SOLID WASTE AUTHORITY

RE: Solid Waste Authority of Palm Beach County
North Country Regional Resource Recovery Project
Application for Modification of Conditions of Certification and
Reissuance of Prevention of Significant Deterioration Permit

The Solid Waste Authority and the NCRRRF operator, B&W have reviewed DER's proposed permit modifications (PSD-FL-108A) as transmitted in their May 2, 1991 correspondence to the SWA, and offers the following comments.

FIGURE 1
 FLUE GAS TIME/TEMPERATURE PROFILE
 UNIT #1 - NCRRF

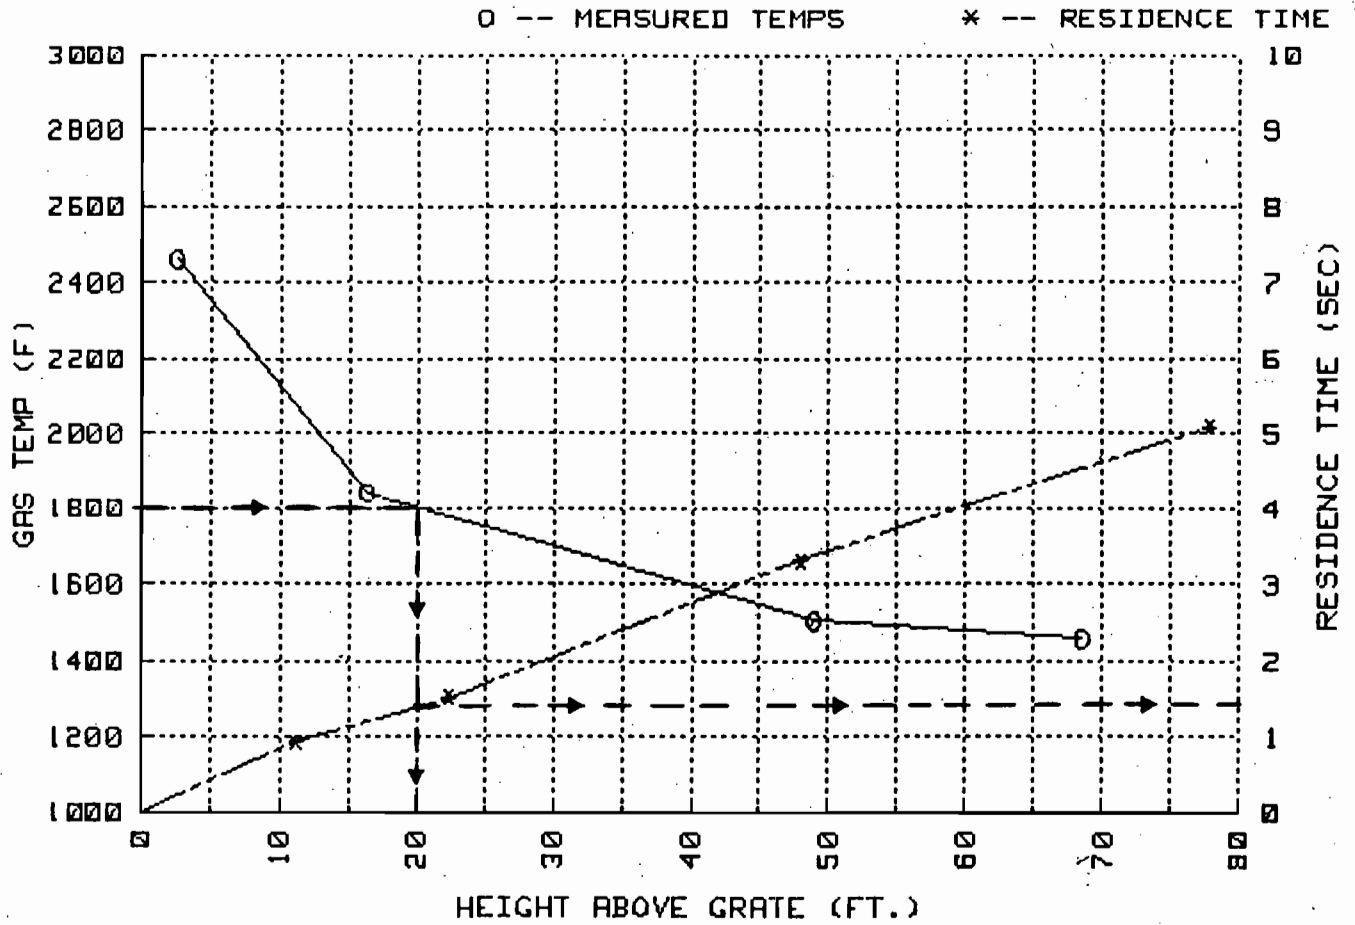
Figure 1 has been revised to correct several minor errors which were discovered in the previous flue gas residence time calculations. Additionally, the "predicted" furnace temperature profile has been removed from the graph in order to avoid any potential misunderstandings relative to the actual test data.

The test data presented in Figure 1 shows that the average flue gas residence time above 1800°F in the NCRRRF boilers is approximately 1.4 seconds. From several different reference points, the following additional time/temperature information can be determined.

Please note that the data presented in Figure 1 was acquired at the current input limit of 360 MMBtu per hour. The flue gas time/temperature relationships will shift with changes in boiler operating load.
